Item Name: Baggage Compartment Protector Floor

DART SERVICE INSTRUCTION

TO AMEND INSTALLATION INSTRUCTIONS IIN-D407-781-2 REV. A OR LATER APPROVED REVISION
AND INSTRUCTIONS FOR CONTINUED AIRWORTHINESS ICA-D407-781 REV. 3 OR LATER REVISION

A	NEW ISSUE		13.04.08
REV.		DESCRIPTION	BY DATE
DESIGN			
DRAWN			
CHECKED			
MFG. APPR.	N/A		
APPROVED			
DE APPR.			
DATE	13.04.08		
		DART AEROSPACE LTD HAWKESBURY, ONTARIO, CANADA	
		DRAWING NO. DSI 9649	REV. A SHEET 1 OF 2
		TITLE ALTERNATE INSTALL	SCALE NTS
COPYRIGHT © 2013 BY DART AEROSPACE LTD. THIS DOCUMENT IS PRIVATE AND CONFIDENTIAL AND IS SUPPLIED ON THE EXPRESS CONDITION THAT IT IS NOT TO BE USED FOR ANY PURPOSE OR COPIED OR COMMUNICATED TO ANY OTHER PERSON WITHOUT WRITTEN PERMISSION FROM DART AEROSPACE LTD.

**FIGURE 1 - D3879-1 BAGGAGE COMPARTMENT WALL
PROTECTOR - ALTERNATE INSTALLATION**

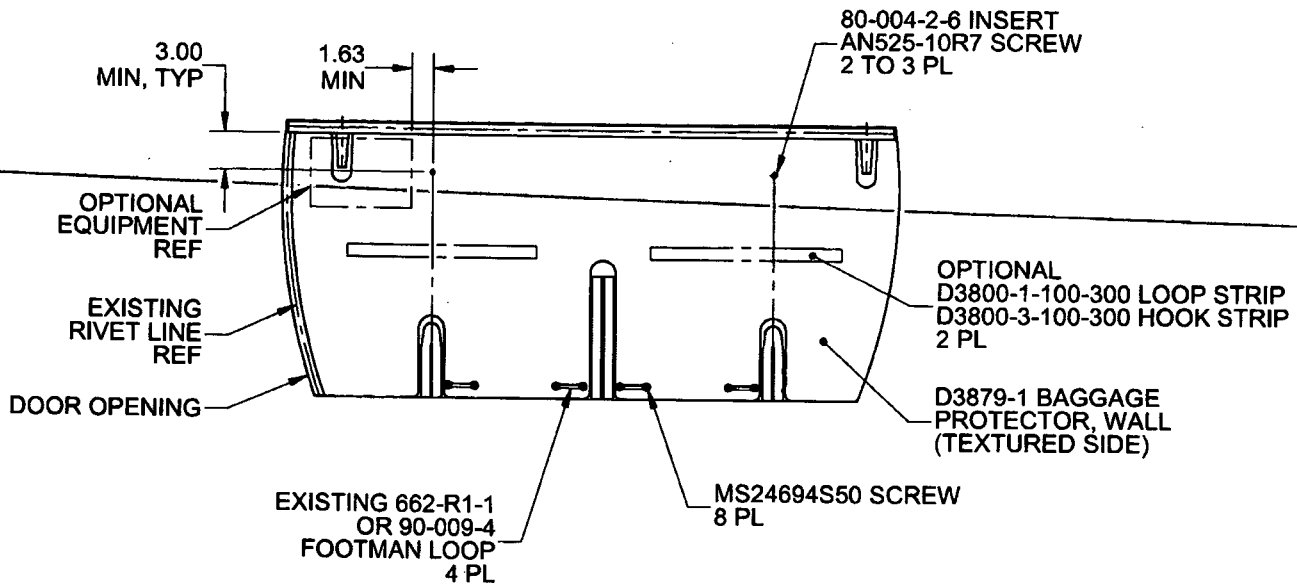
In some aircraft, the top portion of the D206-781-041 Baggage Compartment Wall Protector Kit cannot be installed as indicated in IIN-D407-781-2. The purpose of this DSI is to provide an alternate mounting method to fasten the top portion of the D206-781-041 Baggage Compartment Wall Protector Kit.

It is acceptable to replace qty(2) D3930-1 Clips with qty(2) 80-004-2-6 Inserts. Locate and mark location of the two attachment holes on the baggage compartment wall as shown in Figure 1 of this service instruction. Install 80-004-2-6 Inserts at the marked locations in accordance with Section 3-2-12 of BHT-206-SRM-1. It is acceptable to trim the wall protectors to accommodate optional equipment or transfer attachment holes to the wall protector and install the optional equipment on top of the wall protector with longer fasteners.

Amend the D206-781-041 Baggage Compartment Wall Protector Kit parts list as follows:

Qty -061	Qty -031	Qty -041	Part Number	Description
X			D206-781-061	BAGGAGE COMPARTMENT PROTECTOR KIT (FLOOR AND WALL)
1	X		D206-781-031	BAGGAGE COMPARTMENT FLOOR PROTECTOR KIT
1		X	D206-781-041	BAGGAGE COMPARTMENT WALL PROTECTOR KIT
		2	AN525-10R7	SCREW
		2	80-004-2-6	INSERT
